IMPLEMENTATION REQUIREMENTS

By letter dated January 12, 2009, Electric Power Research Institute submitted for U.S. Nuclear Regulatory Commission (NRC) staff review Topical Report (TR) 1006596, "Materials Reliability Program (MRP): Pressurized Water Reactor Internals Inspection and Evaluation Guidelines." Upon review of the information provided, the NRC staff has determined that additional information (RAI) is needed to capture the initial set of technical questions related to the NRC staff's review of TR MRP-227 to support completion of the review. The NRC staff will however issue another set of RAIs based on its review of the MRP-227 report and its supporting reports. By e-mail dated August 22, 2009, Ms. Christine King, Program Manager, MRP, and I agreed that the NRC staff will receive your response to the enclosed RAI questions within 60 days of issuance of this letter. If you have any questions regarding the enclosed RAI questions, please contact me at 301-415-3610.

Figure 2.1 from MRP-227

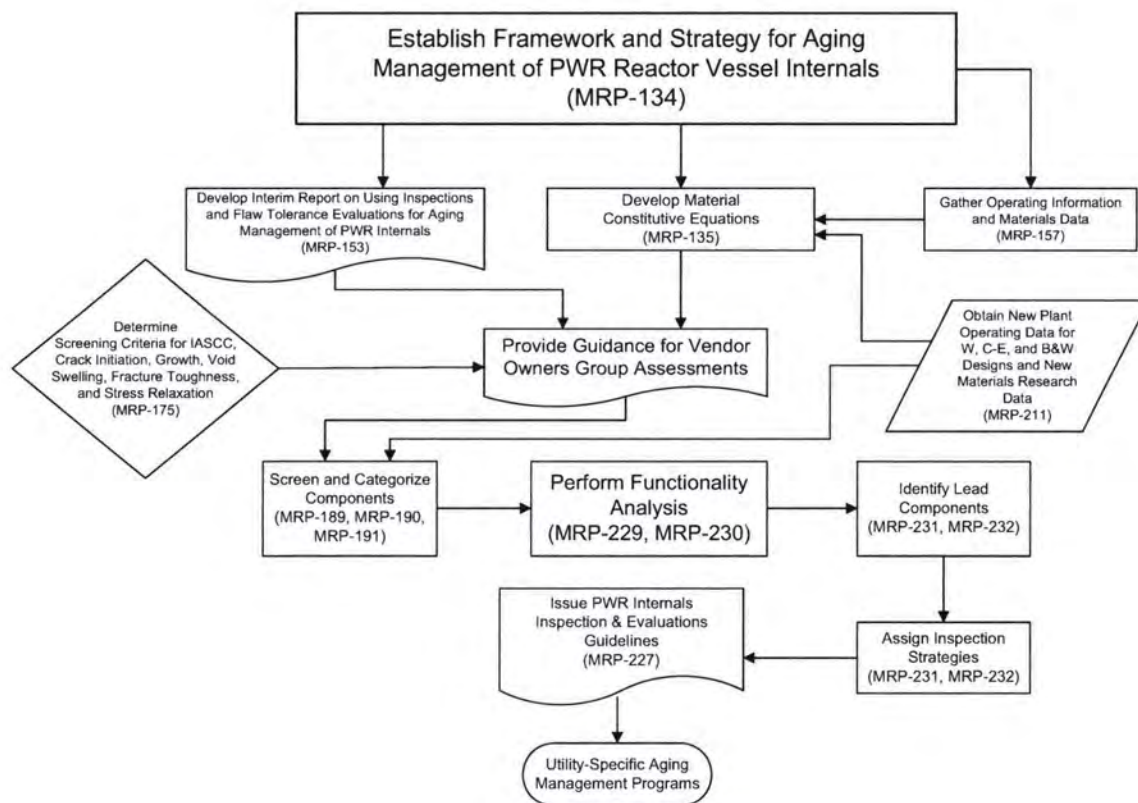
RAI 3-2 TR MRP-227, Rev. 0, does not make reference to Nuclear Energy Institute (NEI) Report No. NEI 95-10, Revision 6,² 2 as an applicable industry license renewal report; nor does TR MRP-227, Rev. 0, provide any discussion on how it will be used to conform to the recommendations in NEI 95-10, Rev. 6, when implementation of the I&E recommendations are applied as license renewal activities and methods for aging management of RVI components. Discuss how and provide the basis for why the recommended I&E scoping/screening process, inspection activities, evaluation methods and acceptance criteria in TR MRP-227, Rev. 0, are considered to be in conformance with the recommendations in NEI 95-10, Rev. 6, paying particular attention to conformance with Chapters 2, 3, and 4 of the NEI 95-10, Rev. 6, and the license renewal processes identified therein for implementation in Figures 2.0-1, 3.0-1, 4.1-1, 4.2-1, and 4.3-2.

MRP-227, Revision 0 summarizes the results of industry programs for investigating and managing these aging effects in reactor internals and provides recommendations for the implementation of those results. A graphical representation of the process is depicted in MRP-227, Revision 0 Figure 2-1. The MRP-227, Revision 0 methodology begins with an extensive effort to identify materials, environment, stresses, service conditions, operating experience and other relevant information as required by SRP-LR BTP RLSB-1. This initial effort is described in MRP-134, MRP-135, MRP-153, MRP-157 and MRP-211. The second step in the process defines screening criteria that can be used to identify conditions that can potentially result in component degradation. Screening criteria were developed for eight relevant degradation mechanisms. These relevant degradation modes included the mechanisms identified in the GALL as “AMR Results for Which Further Evaluation is Recommended.” Each component was compared to the MRP-175 screening criteria to identify applicable aging effects. The results of the screening process are reported in MRP-189, Revision 1 and MRP-191. This screening process is integral to the AMR and should not be confused with the screening process used to identify passive components per 10 CFR Part 54.21(a)(1).

groupings prior to aging management program definition. SRP-LB BTP RLSB-1 specifically states that: “The risk significance of a structure or component could be considered in evaluating the robustness of an aging management program.”

The transition from “applicable aging management effects” represented by MRP-189, Revision 1, MRP-190, and MRP-191 to “aging management program elements” is provided by MRP-231 and MRP-232, from which the requirements of MRP-227, Revision 0 were extracted and refined. The inspection guidelines provided in Section 4 of MRP-227, Revision 0 provide the basis for the program elements required in an AMP. Appendix A of MRP-227, Revision 0 summarizes the AMP Program Attributes required by NUREG-1800, Revision 1. The MRP-227, Revision 0 document is intended to provide the technical basis for an AMP. This appendix describes the extent to which the MRP-227 guidelines and supporting documents satisfy the AMP requirements. The MRP has agreed to work with the NRC to have these AMP recommendations incorporated in the upcoming GALL revision.
